**Questions & Answers Document No. 1**  
**Next Generation Fare Gates Project**

**Request for Expressions of Interest**

**November 6, 2020**

REF. NO.	
SIZE: SCALE	
CONTRACT NO.	REV. 06
SHEET NO. J006	PAGE NO.

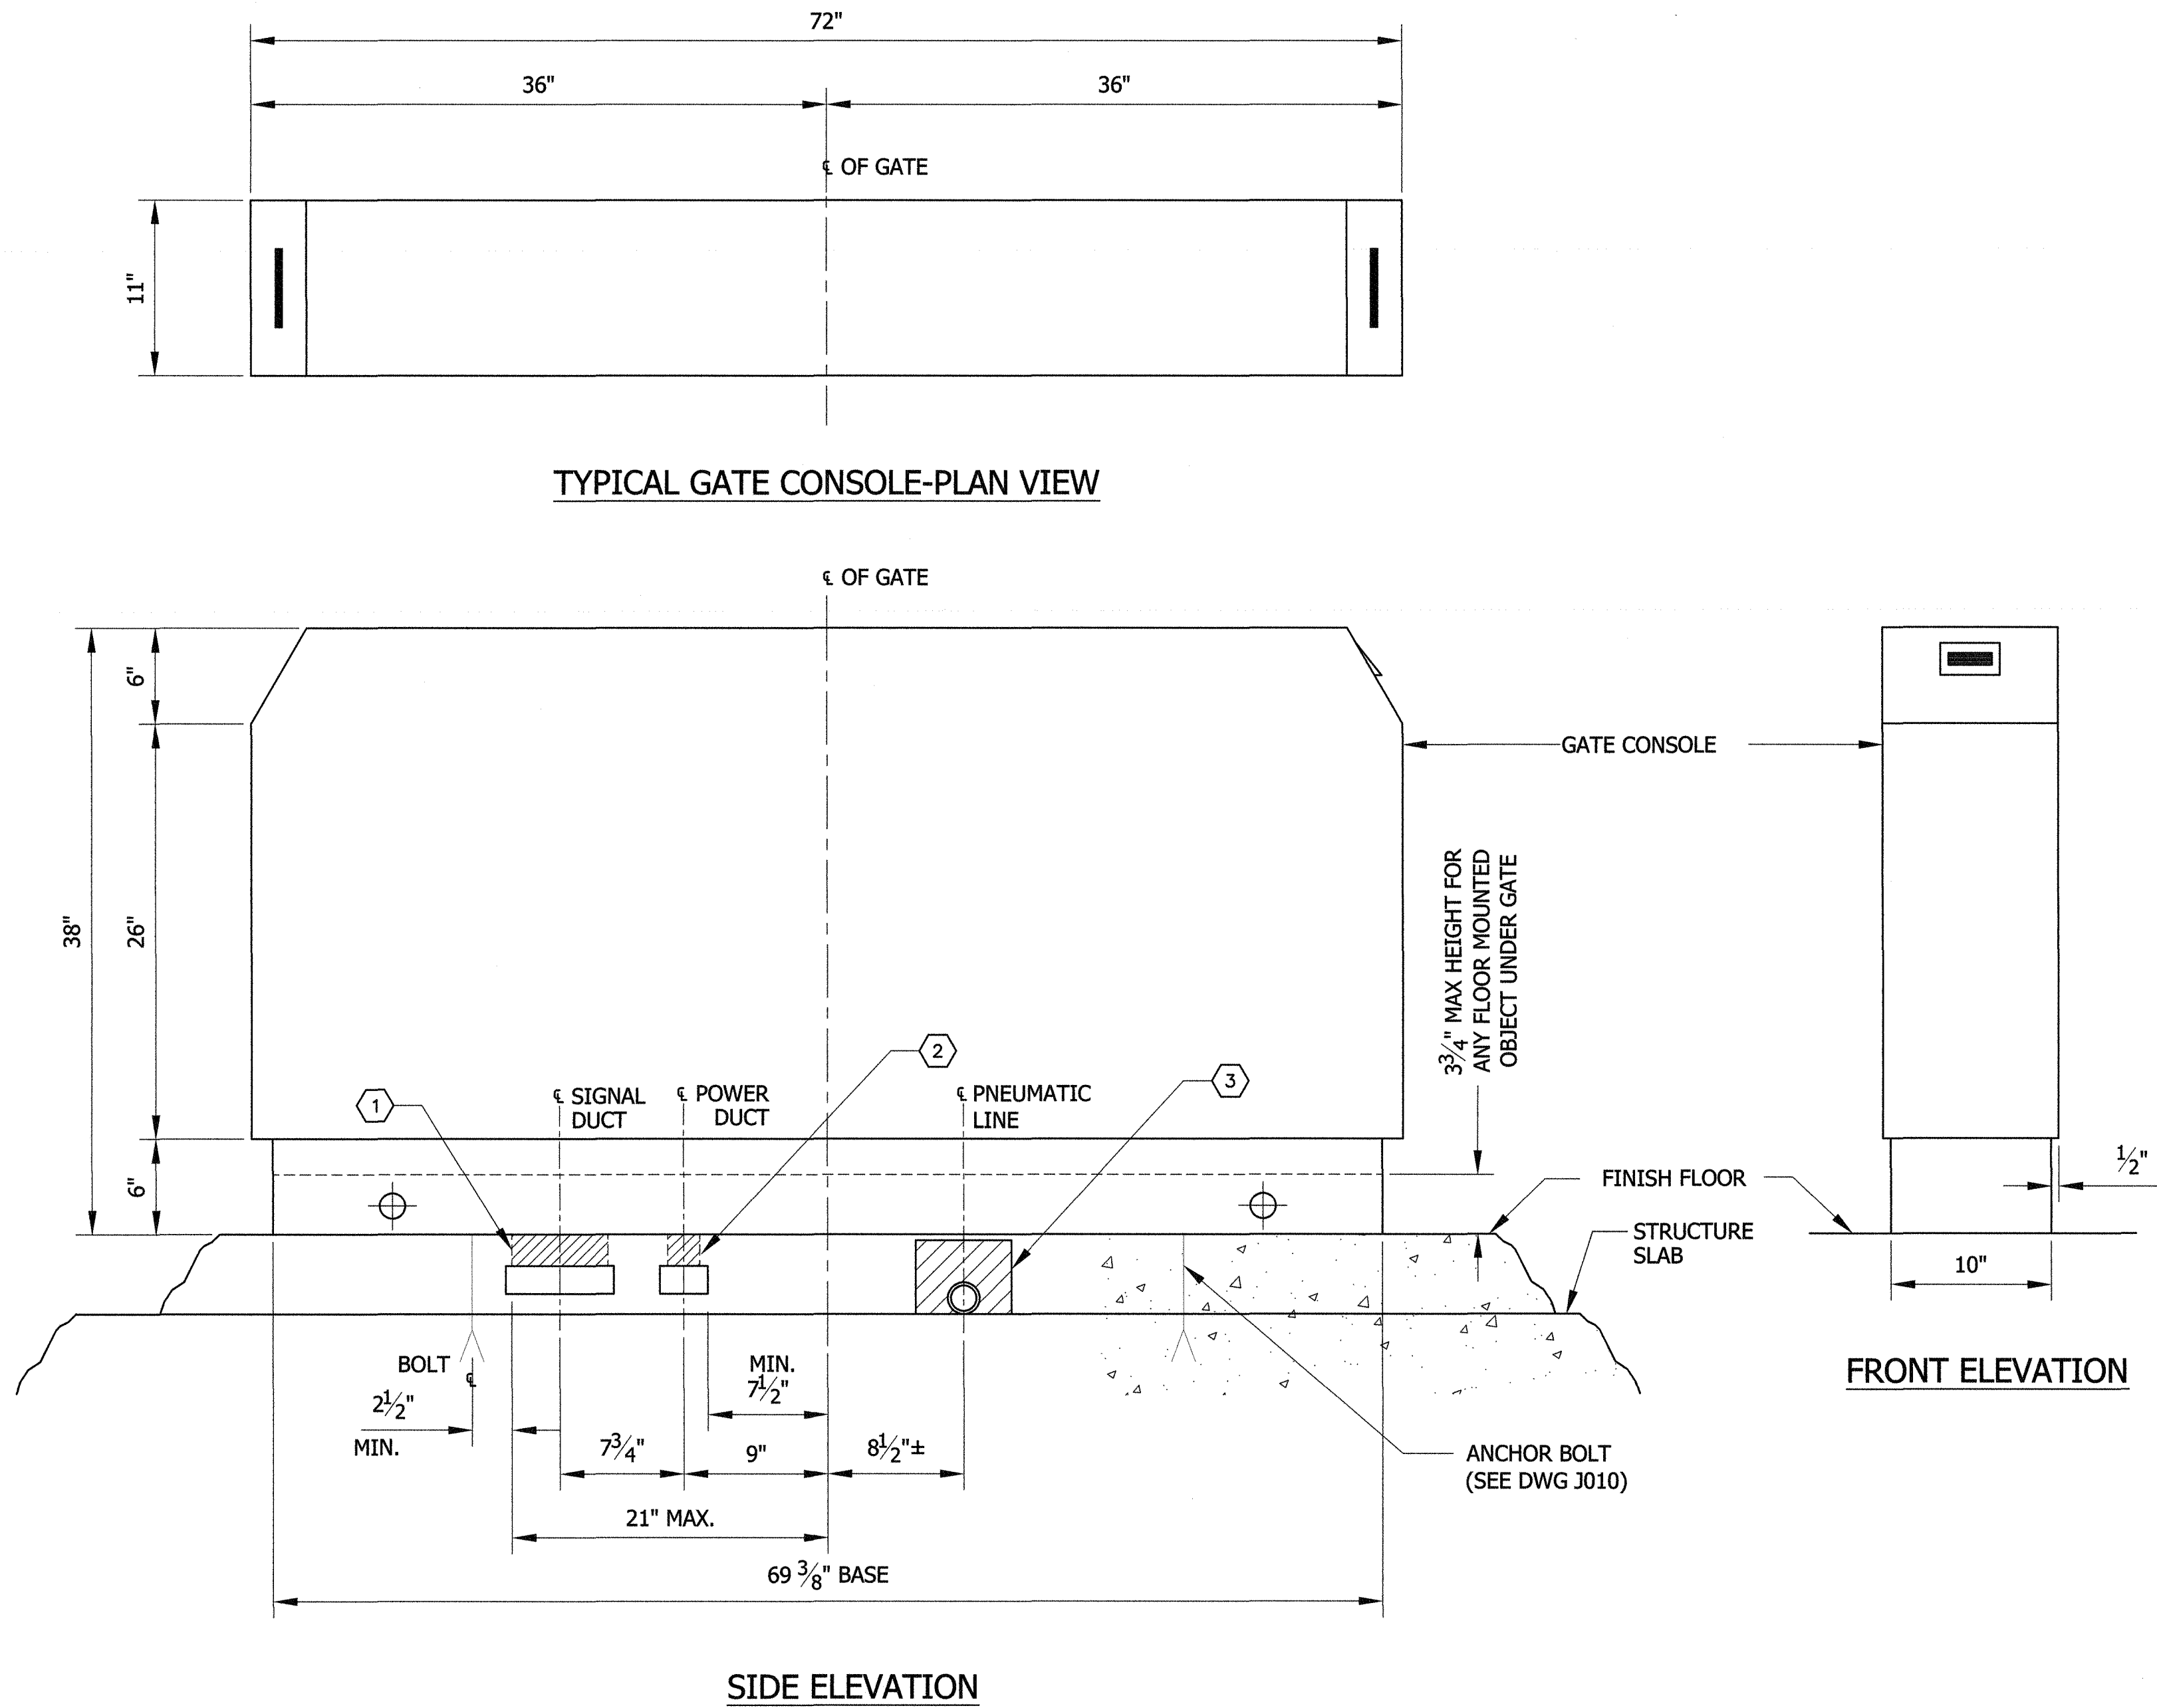
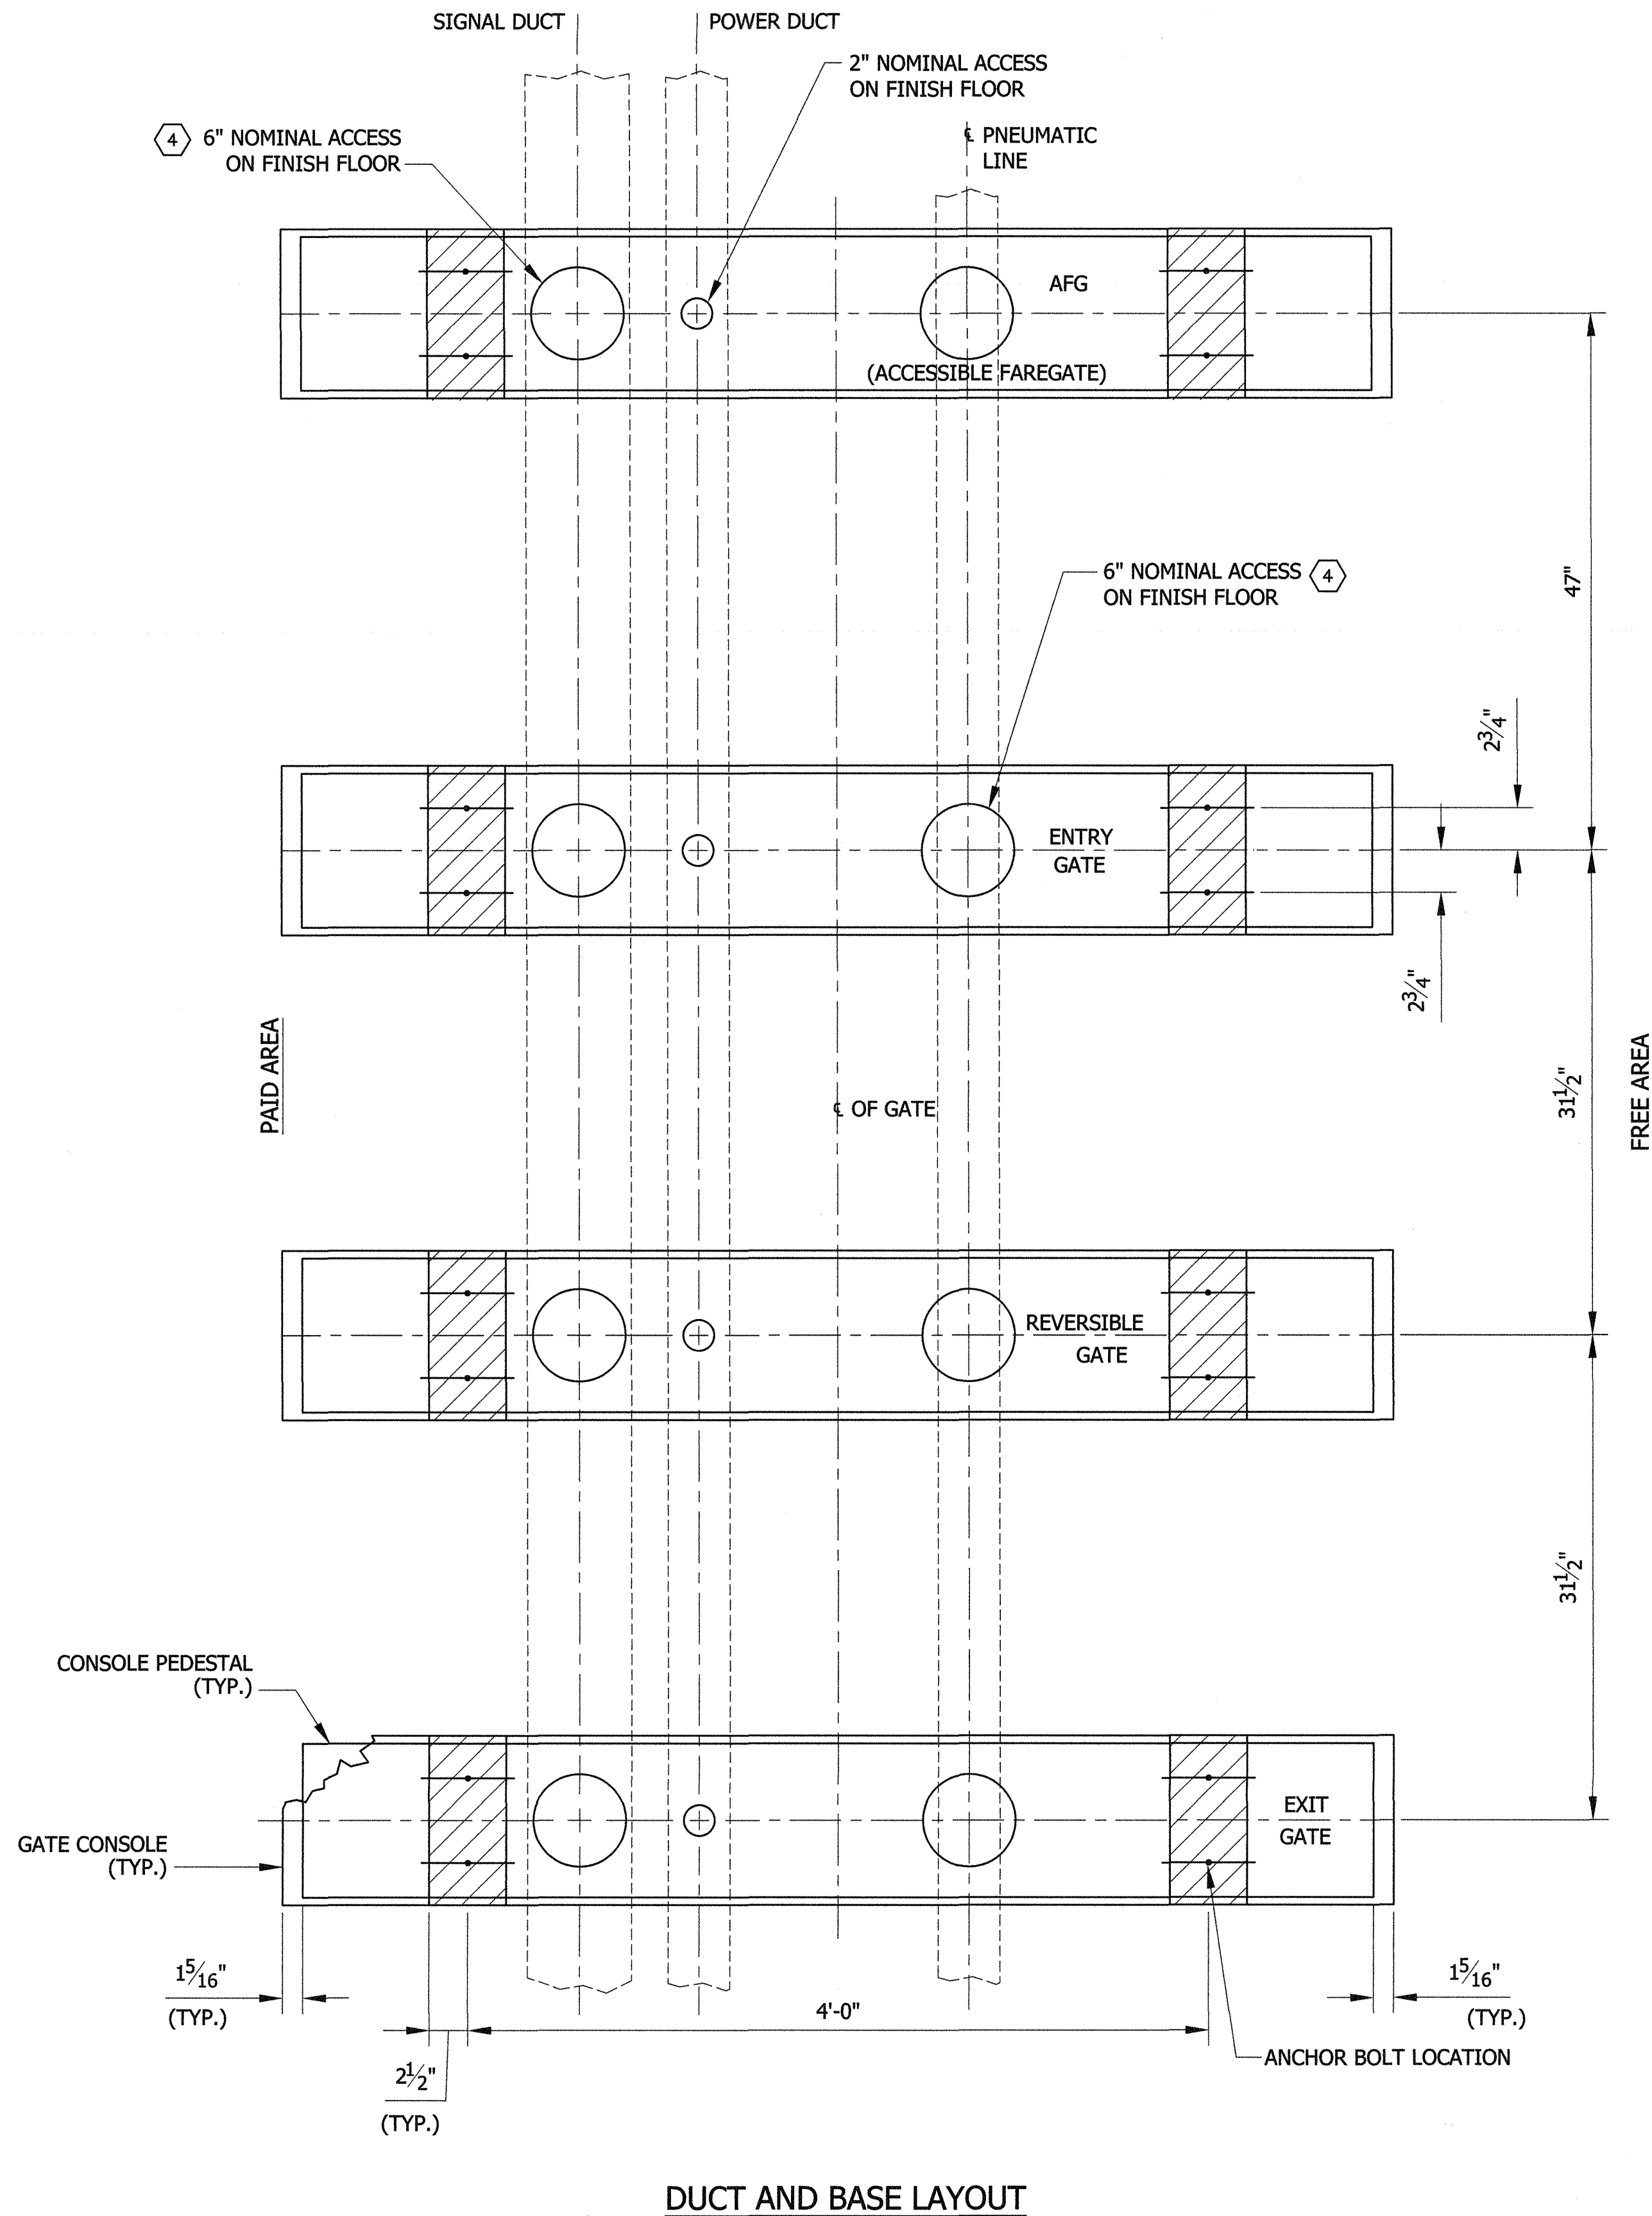
**Q26. Please provide engineering drawings showing dimensions for legacy system and pilot fare gates.**

A26. Please see Exhibit 1, drawing J006 for legacy fare gate dimensions. The retrofitted pilot fare gate's console dimensions are the same other than the height of the bi-parting swing barriers.
